**Town of Kittery
Planning Board Meeting
April 12, 2018**

459 U.S. Route One – Mixed-use development – Site and Subdivision Preliminary Plan Review

**RE: Town of Kittery, Planning Board Services
Site Plan Review Application-The Homestead 459 U.S. Route 1 (Tax Map 60, Lot 24)
CMA #591.115**

2.1 GRADING AND UTILITY PLAN
THE HOMESTEAD
459 US ROUTE 1 KITTERY, MAINE

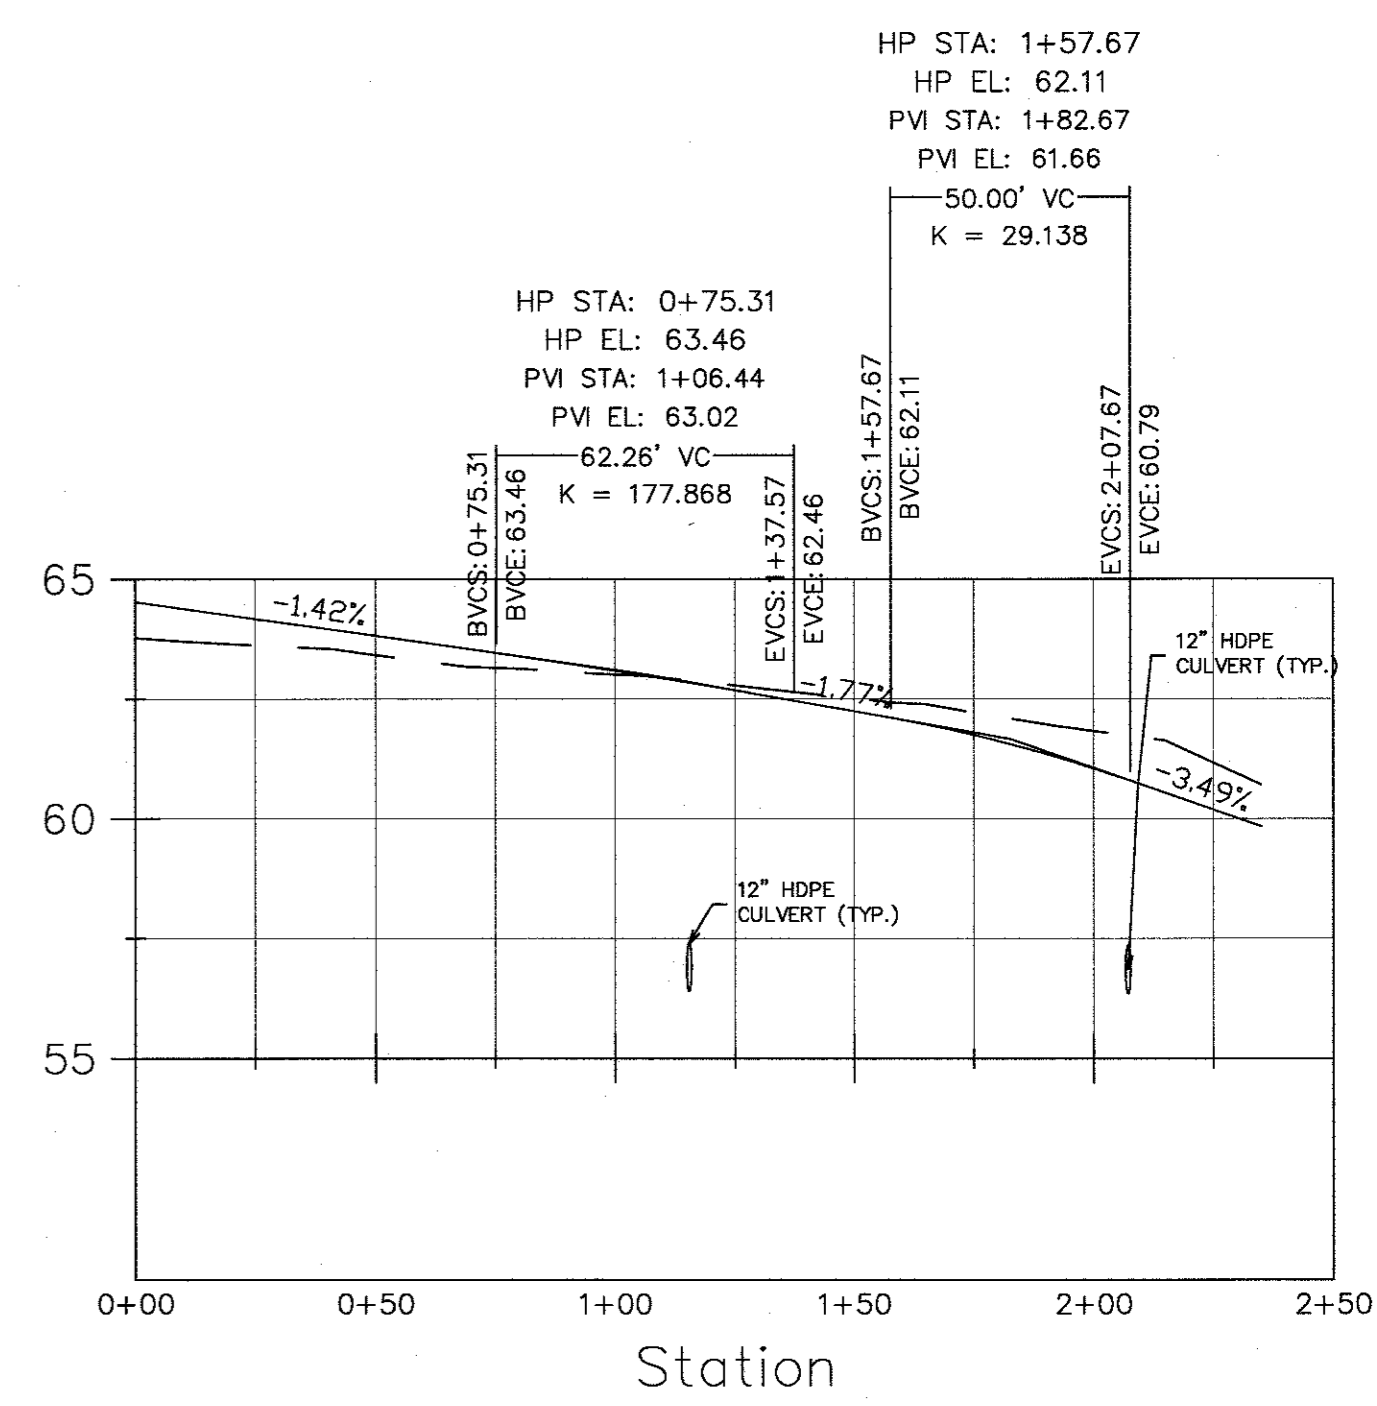
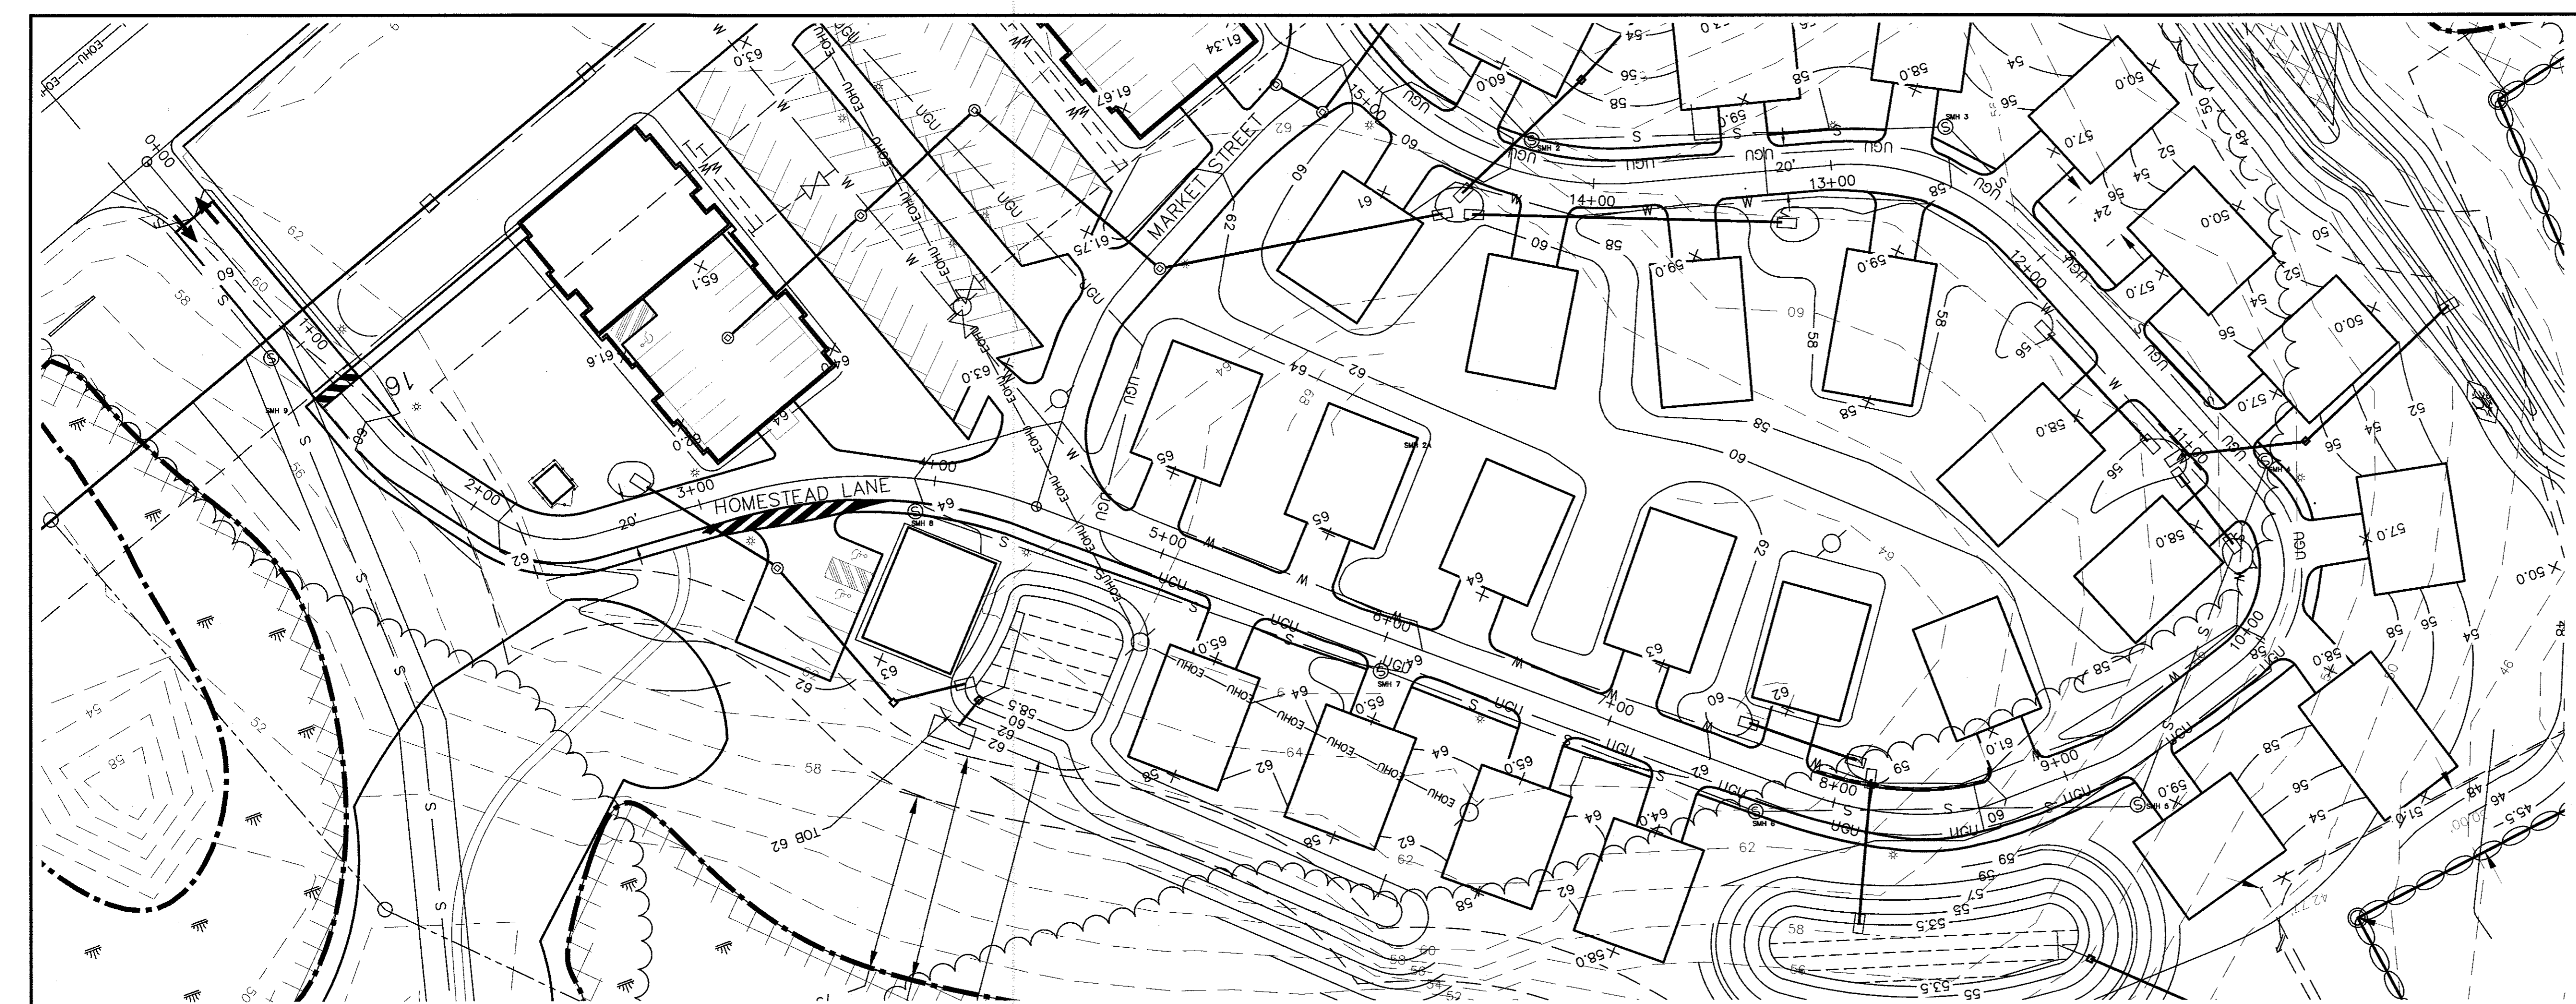
14. On Plan Sheet 2.1 and perhaps others, an arrow labeled “retaining wall” does not seem to point to anything. Is there a wall proposed?
15. The Applicant states that the road will remain private – a note should be added to Plan Sheet 1.1 indicating that the roads will remain private and the Town has no responsibility for maintenance or repair of the roads, snow plowing or stormwater system maintenance.

1. The applicant should provide an existing conditions plan.
2. There are discrepancies in supporting documentation about the number of units proposed.
3. There are leaders on Sheet 2.1 that do not point to anything and do not seem to apply (12" HDPE, retaining wall, 50' wetland setback).
4. There doesn't appear to be access to the dumpster pad.
5. Who is the dumpster intended for?
6. There are items in the legend that are not on the plans (retaining wall, etc.)
7. Where is the location of the timber guardrail?
8. The plans should clearly show which units have 560 sf of commercial/office space.

WATER SERVICE DETAIL
NTS

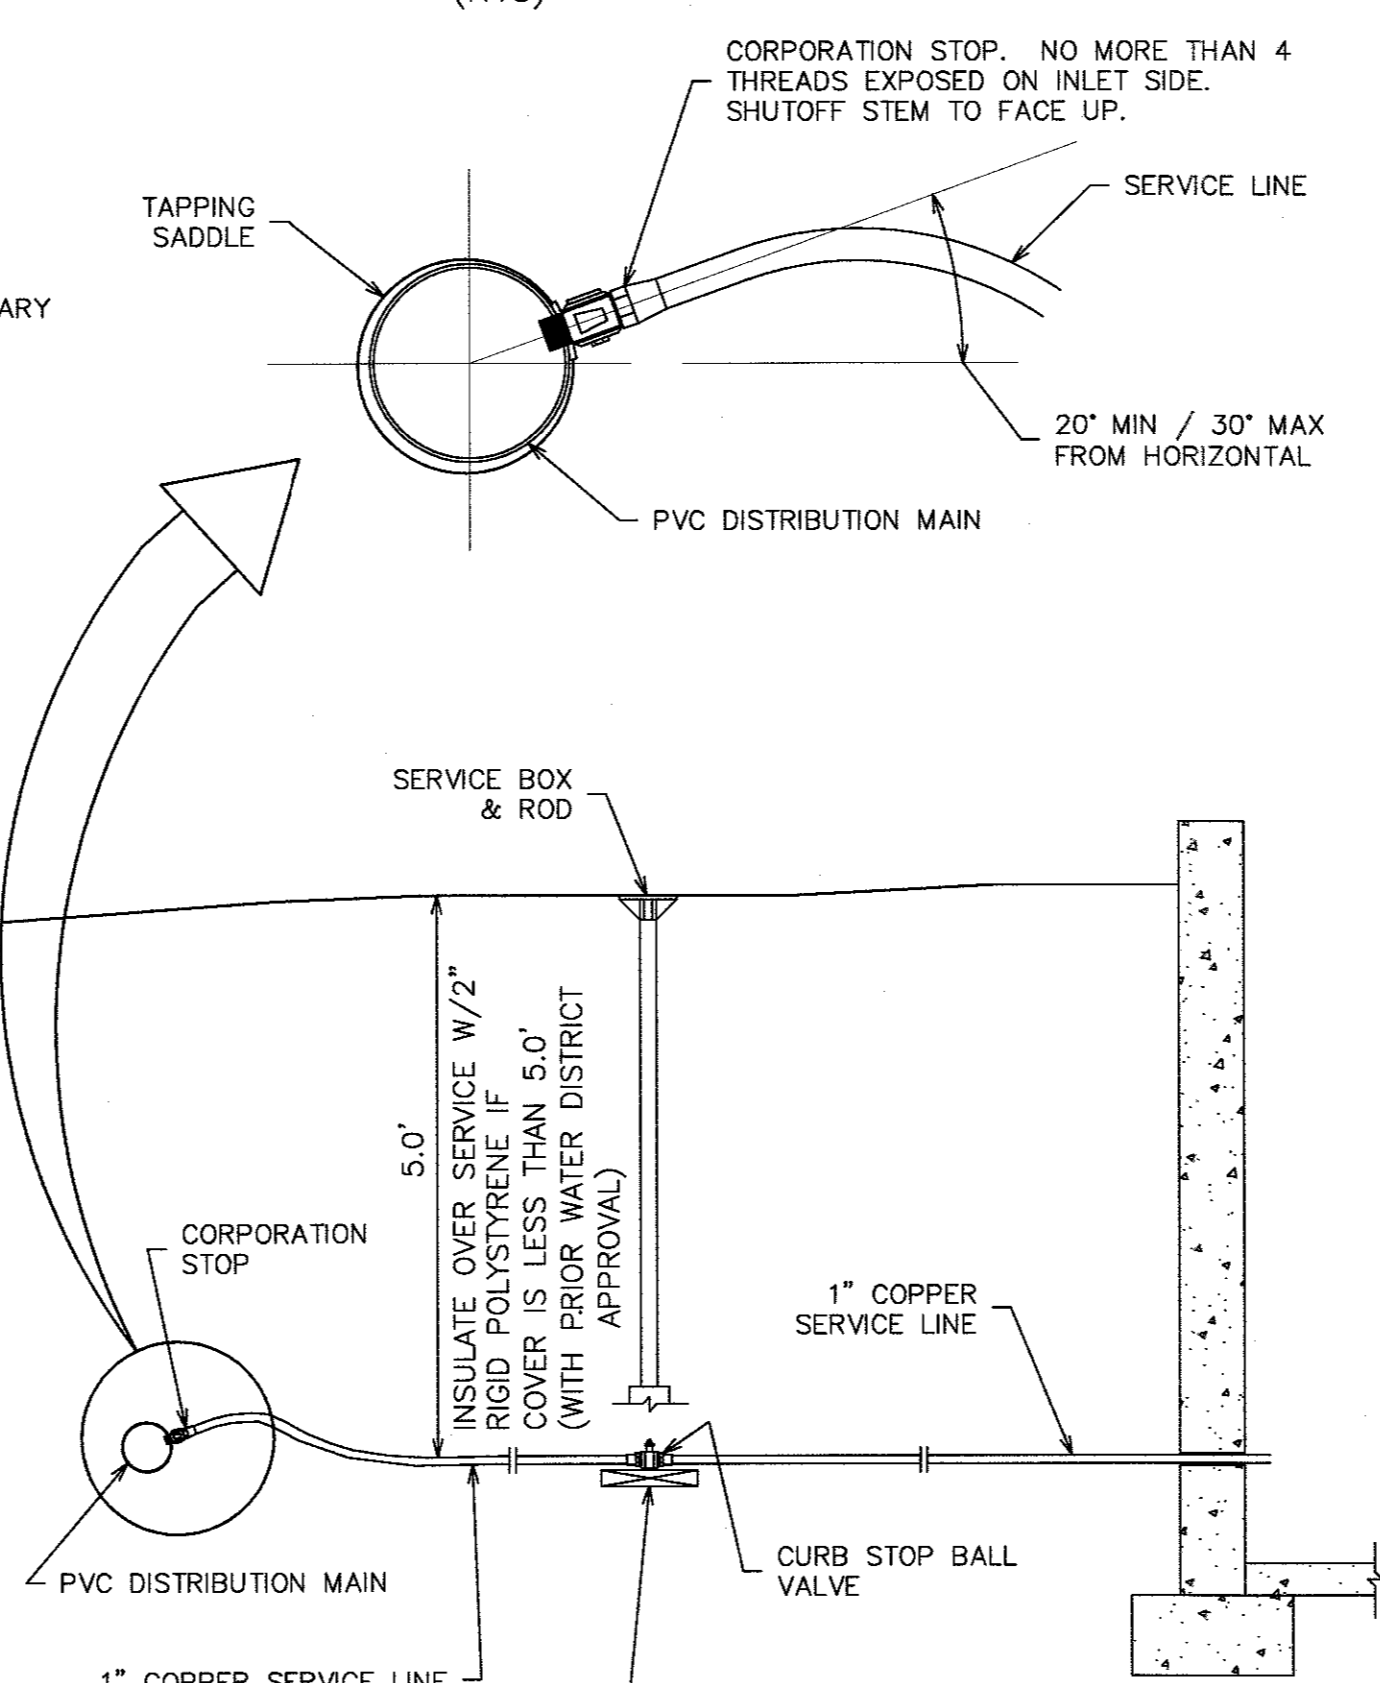
- 16.8.6.1 The applicant should show the existing water main location in U.S. Route 1 and provide information on main material and size.
Proposed water service locations and curb stops should be shown on the plans.
Show how the existing relocated hydrant will tie in to the existing or proposed water main. Is this the only hydrant for the site?
Water service detail calls out the main as PVC not ductile iron.

ROAD CROSS SECTION
SCALE: NTS

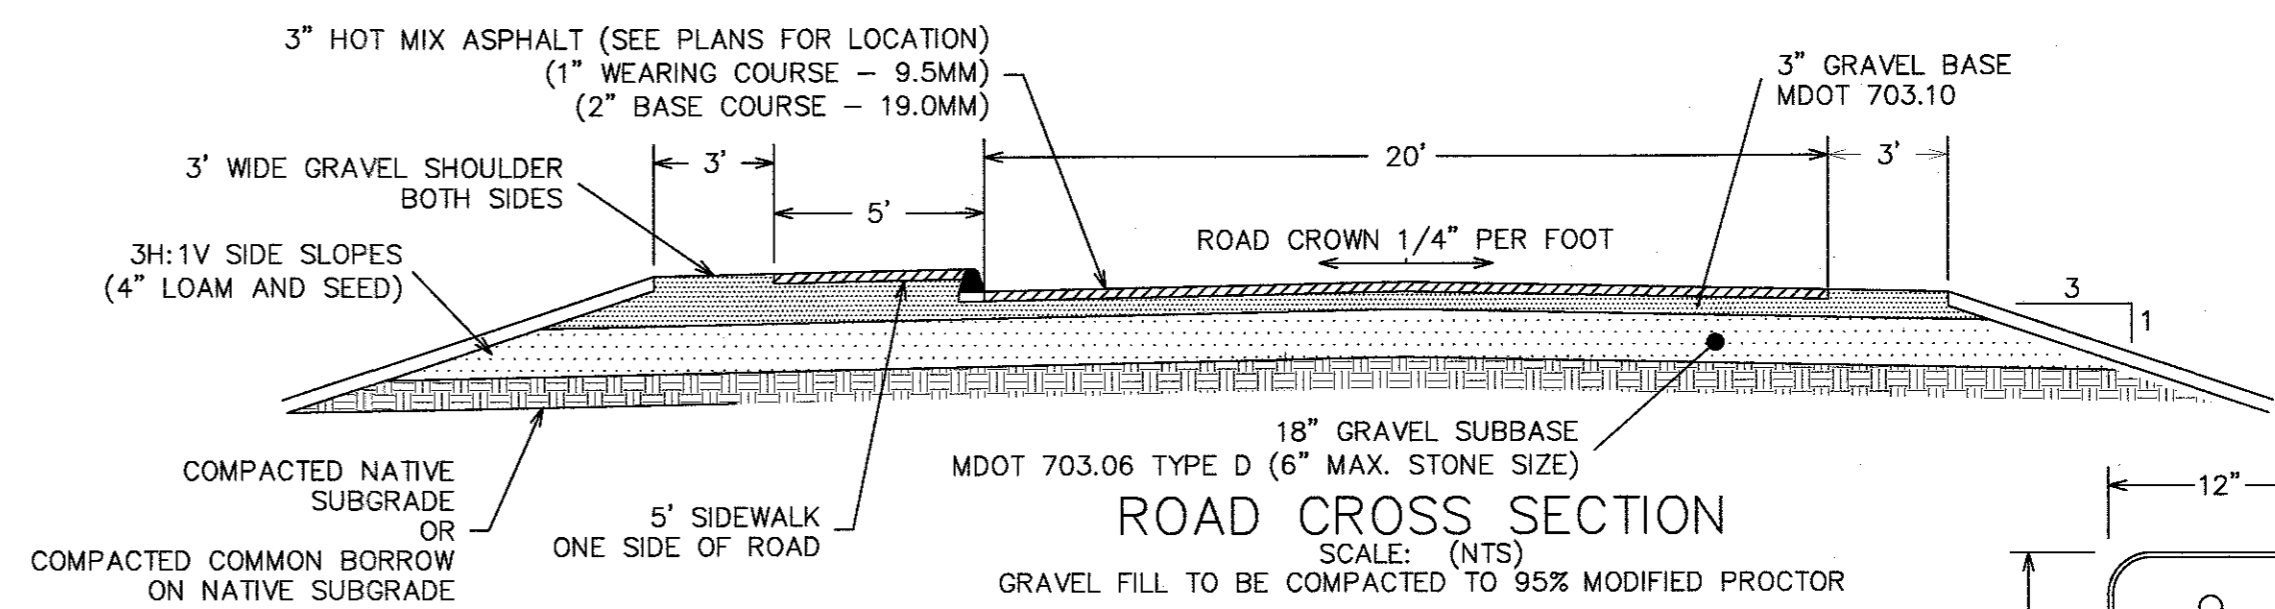
The applicant should include the width of the right-of-way on the roadway detail.

UNDERDRAINED SOIL FILTER POND 40P

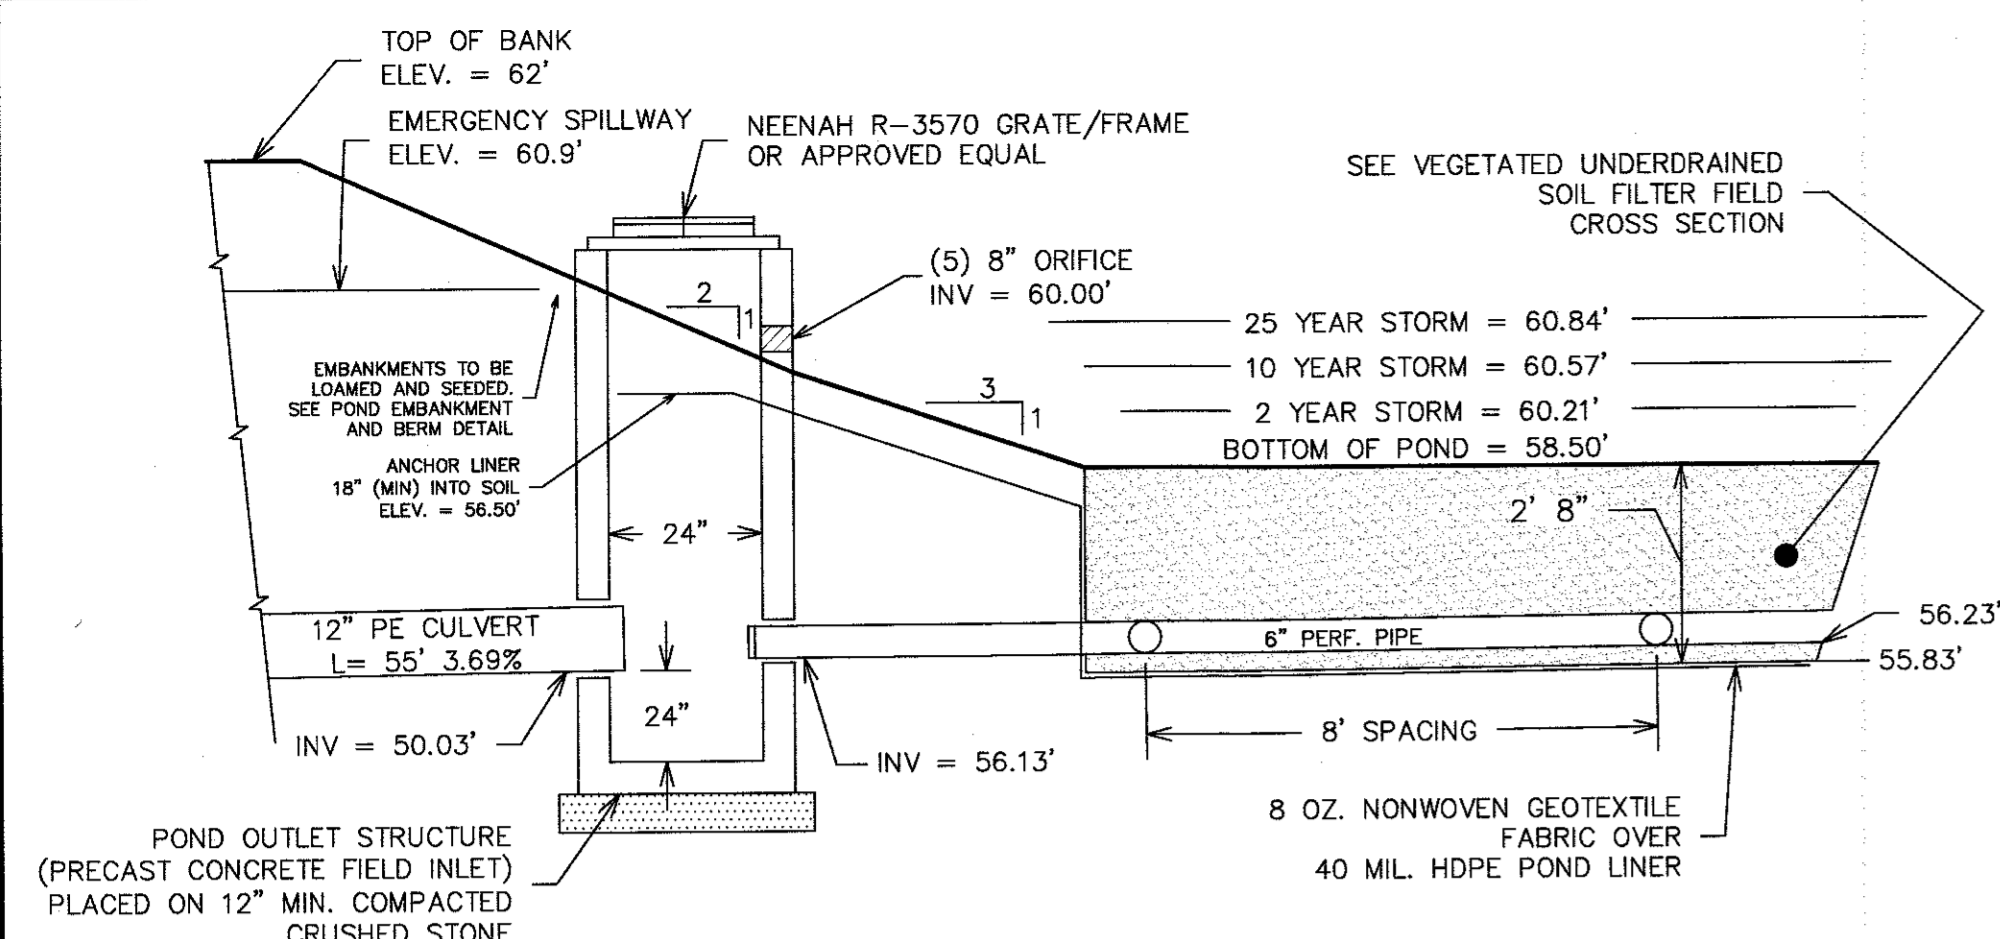
- Pipe sizes should be included on the drainage structure schedule.
- The detail for Underdrained Soil Filter Pond 40P shows an incorrect invert out (50.03').
